# UNITED STATES PATENT AND TRADEMARK OFFICE

APPLICATION NO.	FILING DATE	FIRST NAMED INVENTOR	ATTORNEY DOCKET NO.	CONFIRMATION NO.
10/661,847	09/12/2003	Charles Edward Boardman	24-AT-135243	8534

<b>Office Action Summary</b>	<b>Application No.</b> 10/661,847	<b>Applicant(s)</b> BOARDMAN ET AL.	
	<b>Examiner</b> DANIEL L. GREENE	<b>Art Unit</b> 3694

## **DETAILED ACTION**

FIG. 3

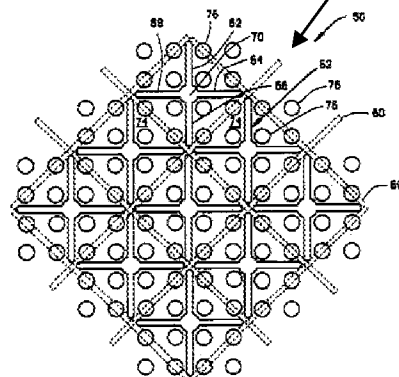
Second, the similarities between Figure 3 of Challberg and Figures 4 and 5 (next page) of the instant application cannot be disregarded.

FIG. 5

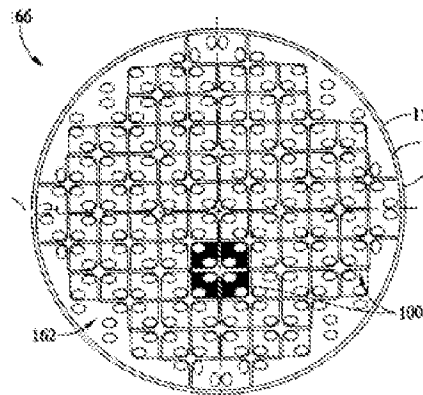
Clearly it is considered well within the skill of one of ordinary skill in the art to separate the integral support plate of Challberg in a myriad of ways for the benefits already of record. For example, looking at figure 3 and applying case law, one could easily subdivide or cut the plate apart in the manner set forth immediately below.

FIG. 3

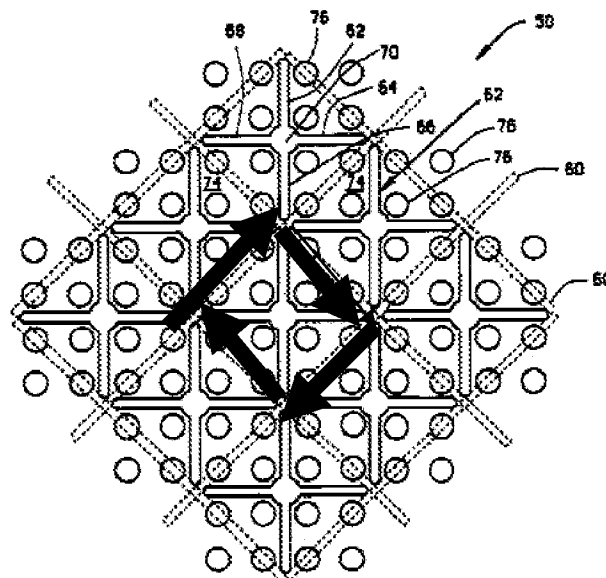
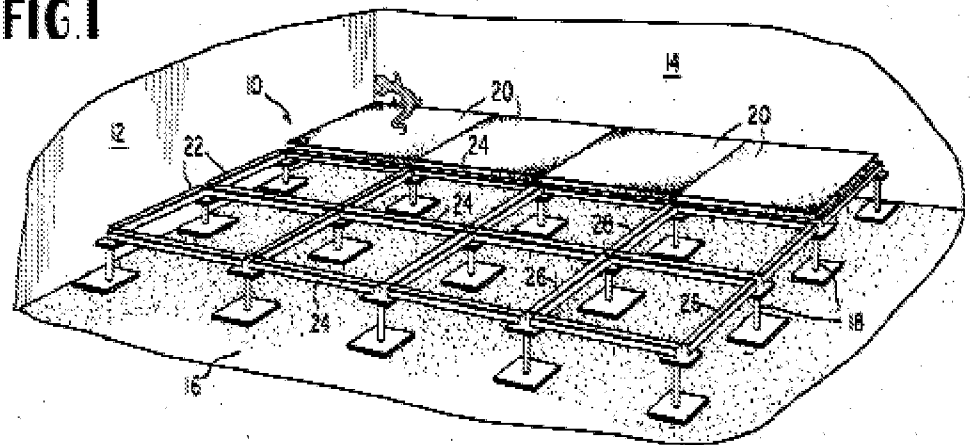
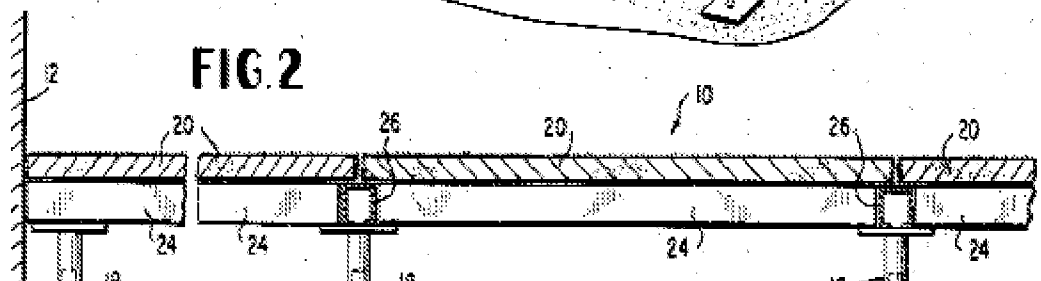
This type of separation of parts appears to most directly reflect a modification from the secondary references by placing the groove around the outside edge of each individual segment (support block) to engage the underlying support grid, much like a ceiling or floor tile such as from Bettingers Figures 1 and 2.

FIG. 3

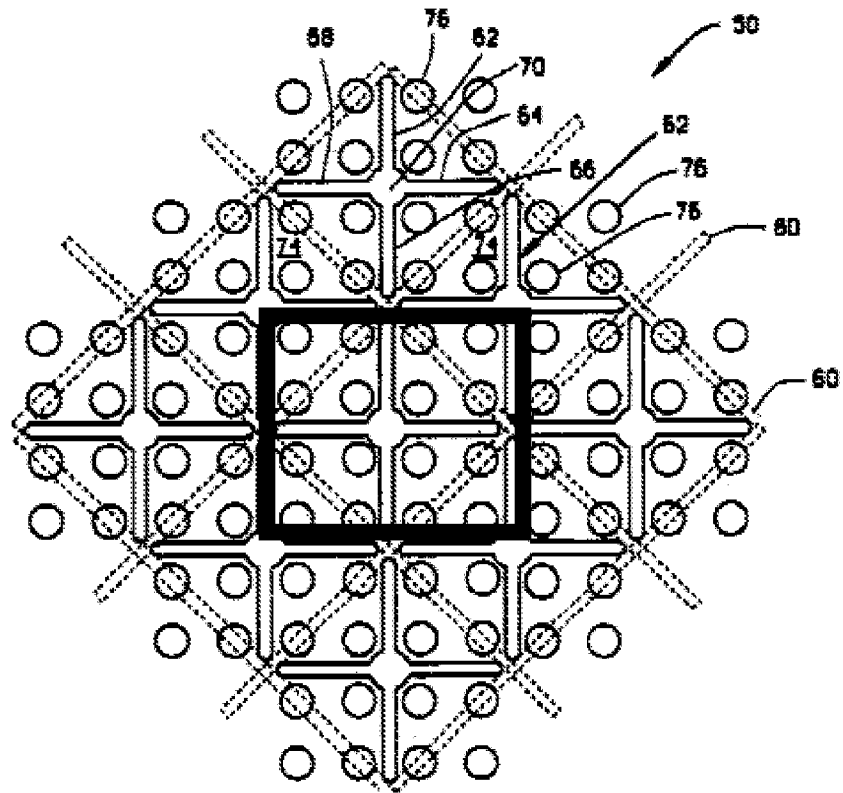
However, it is noted that applicant did not separate the integral support plate in the same manner, instead, applicant separated the plate along a different line as illustrated immediately below:

The separation of the integral support plate in to multiple individual support plates in this manner would clearly be well within one of ordinary skill in the art because the end result is the same, i.e. the integral plate has been subdivided into smaller units but together they still support the same function as the integral plate itself, i.e. support the reactor fuel assemblies.

As one can see, the separation into individual squares is a design choice as to the direction of the squares (or other examples of arrangements (hexagons, etc.)

set forth in the prior art.) As such it would have been obvious to separate the integral support plate in the manner proposed by applicant.

Accordingly it would have been obvious to one of ordinary skills to use grooves in the manner set forth in the claims by cutting the integral structural support of Challberg apart as show immediately above for the benefit of keeping each individual piece in place. Separating the parts of Challberg in such a manner and applying the use of grooves to maintain alignment would mean that grooves would be located along the dotted lines shown in Figure 3 of Challberg.
